NASA/TM-20230004199
NESC-RP-20-01533

Human Factors Support for On-Orbit Servicing, Assembly and Manufacturing Mission 1 (OSAM-1)

NASA Engineering and Safety Center Technical Assessment Report

NESC-TI-20-01533

Figure 6-1. Initial Design, OSAM-1 MOC
(Console assignments shown are for the Launch, Transit, and Checkout mission phases.)

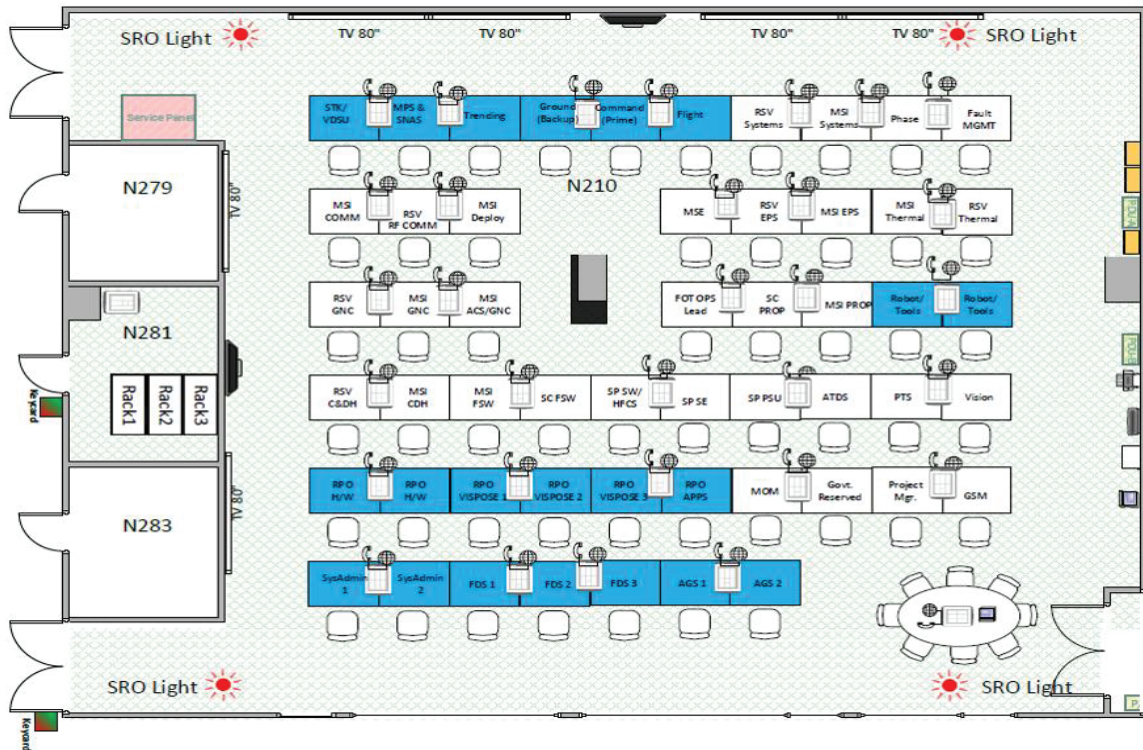
The initial MOC design presented to the NESC team is shown in Figure 6-1 [ref. 3]. This depiction shows the initial 53 positions situated in one operations center, which was a cause for concern to the OSAM-1 and NESC teams. Dedicated consoles for Command Controllers, Phase Leads, the Flight Director, and the Flight Operations Team are highlighted in blue. This arrangement presents an opportunity for distractions, noise, and visual cues that can lead to disruptions during critical mission operations.

Analysis of the room schematics for the initial MOC design indicate that size and placement of wall-mounted displays are constrained by existing equipment, a structural column, doors, and windows that cannot be relocated. Measurements and schematics provided by the OSAM-1 team showed that the MOC ceiling height is 9 feet, and chair headrests (which were already purchased) vary between 47 and 57 inches. This allows only around 4.5 vertical feet for displays, which could lead to visual occlusion from people standing up.

In addition, the NESC assessment team was able to discern from those schematics that the lateral viewing angles from console positions to wall-mounted displays range from 83 degrees for the front row of consoles to 23 degrees for the sixth (i.e., back) row, and viewing distances range from ~9 feet for the front row of consoles to ~39 feet for the back row.

- F-11.** The OSAM-1 MOC design includes 51 console positions in one room, made up of the core command and control team as well as support, planning, and analysis positions.
- F-12.** The Satellite Servicing Projects Division has expressed the need for a barrier within the MOC facility to isolate the core command and control positions from distractions without inhibiting ready access to support, planning, and analysis capabilities.
- R-10.** Erect a configurable portable acoustic partition to create a main control room and back room within the MOC facility. (*F-11, F-12*)

Based on this analysis, the NESC assessment team worked with the OSAM-1 MOC design team to ensure that the shared displays would be positioned in such a way as to ensure visibility, readability, and freedom from obstructions within the room, including personnel.

- F-5.** Size and placement of wall-mounted displays are constrained by existing equipment, a structural column, doors, and windows that cannot be relocated.
- F-6.** The MOC ceiling height is 9 feet, and chair headrests can vary between 47 and 57 inches. This allows only around 4.5 vertical feet for displays, which could lead to visual occlusion from people standing up.
- F-7.** Based on room schematics of the initial MOC design, lateral viewing angles from console positions to wall-mounted displays range from 83 degrees for the front row of consoles to 23 degrees for the sixth (i.e., back) row, and viewing distances range from ~9 feet for the front row of consoles to ~39 feet for the back row.
- R-6.** Position shared displays and consoles to ensure display contents are readable from all console viewing angles. (*F-5, F-6, F-7*)

Figure 7-1. Notional NESC Team MOC Schematic

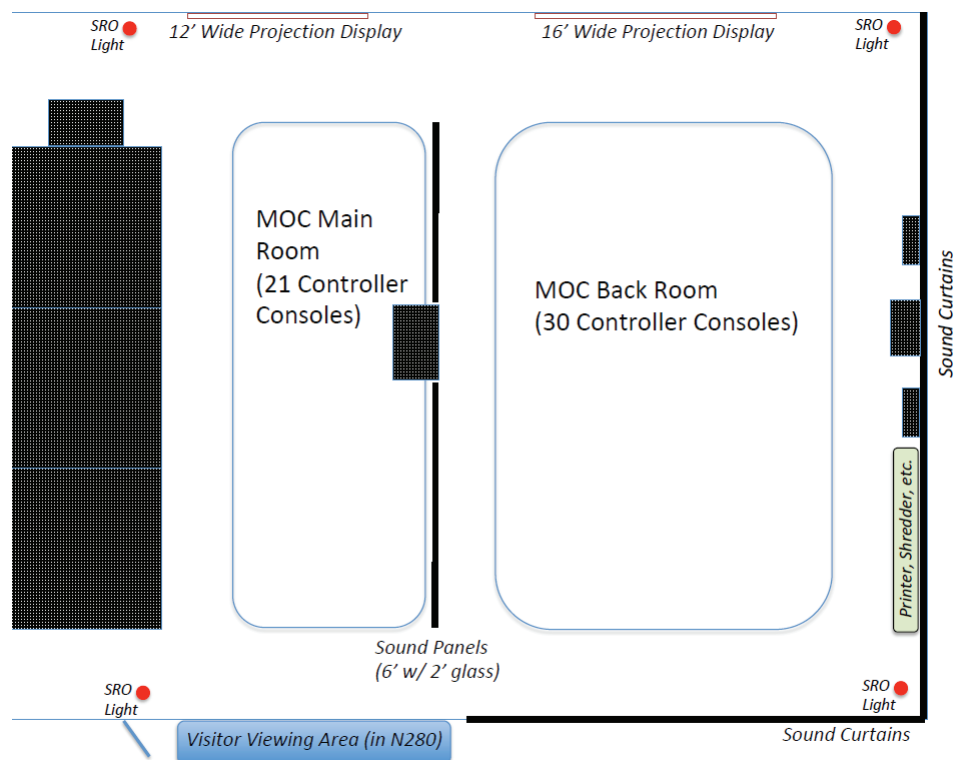
The schematic in Figure 7-1 provides a notional layout of the OSAM-1 Main Control Room, back room, and visitor viewing area (in N280). This schematic has been vetted by the OSAM-1 team and discussed as a viable solution to minimizing distractions in the MOC as well as providing space for supporting positions.

Three doorways provide entry to and exit from the MOC. Two doors open to the main hallway of the building, while a third provides access to a server room that supports multiple facility activities. The OSAM-1 team expressed concern that access to the server room through the MOC creates a distraction as workers not supporting MOC activities pass through to move equipment.

- R-13.** Restrict normal ingress/egress through one of the two doorways that connect the MOC to the adjacent hallway to direct the flow of foot traffic into the MOC away from the location of the core command and control team. *(F-16, F-17, F-18)*
- R-14.** Provide a location, within walking distance from the MOC, for personnel to have breaks, meals, and informal conversation. *(F-17)*
- R-15.** Provide access to a dedicated conference room for operational discussions that would be too disruptive or impractical to hold within the MOC or proposed break room. *(F-18)*
- R-16.** Provide shift schedules that allow required time off for OSAM-1 MOC personnel, as stated in NPR 1800.1D, and balance mission logistical requirements with effects of shift duration on operator performance. *(F-19)*
